# WEST PASCO MODEL RAILROAD

## DESIGN TEAM MEETING NOTES

**TITLE:** Rethinking, but approving the main lines

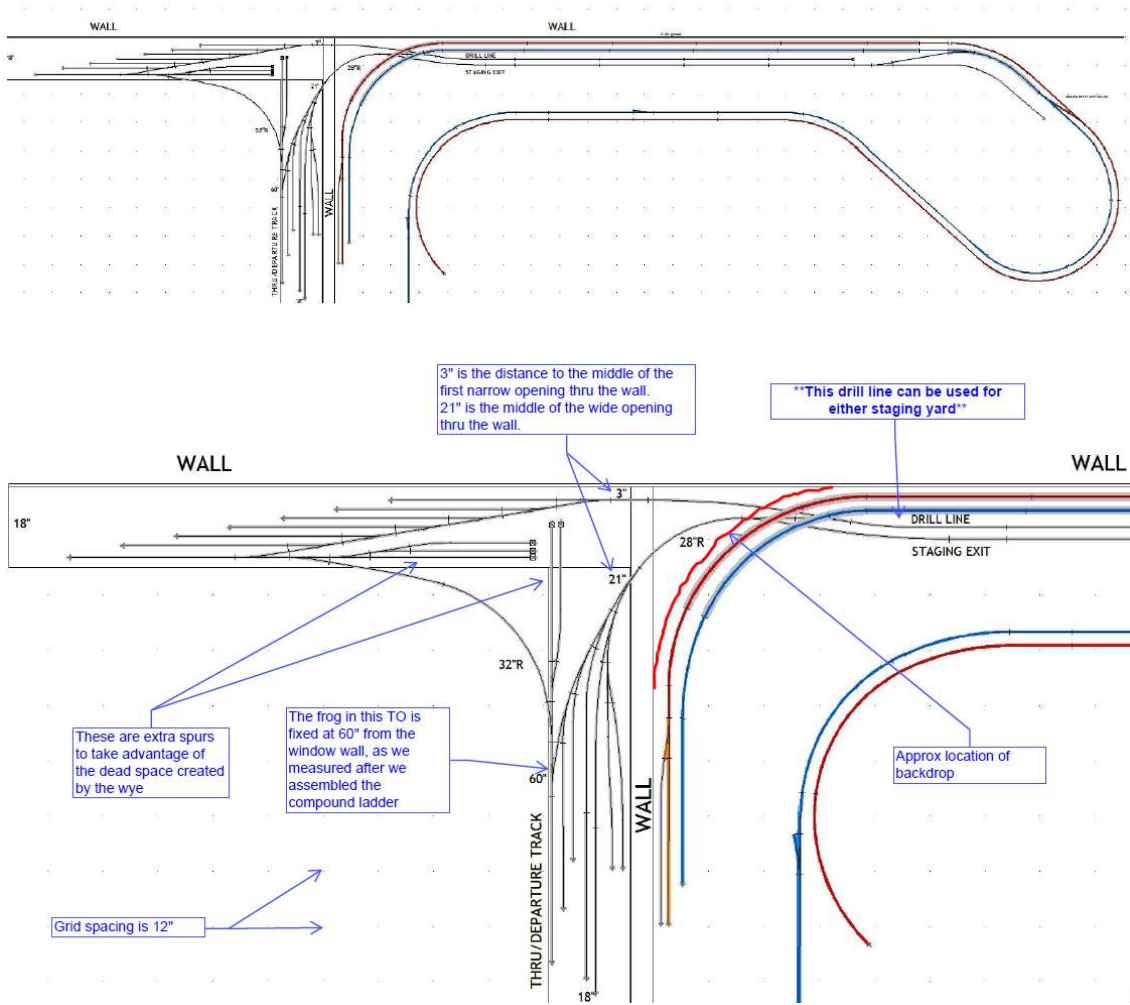
Due to some discussion about clearances for bridges and flyovers, Bill did some measurements and calculations to locate the correct clearance specification.

*The absolute minimum clearance needed between top of cube and structure above is 3" so if we add another 0.5" for grade buffer, 0.75" for sub-roadbed, 0.25" for cork, and 0.1" for rail, the minimum rail to rail vertical height is 4.6 inches (or 4-5/8"). So Ralph's suggestion of 5" for rail to rail height would be more than adequate.*
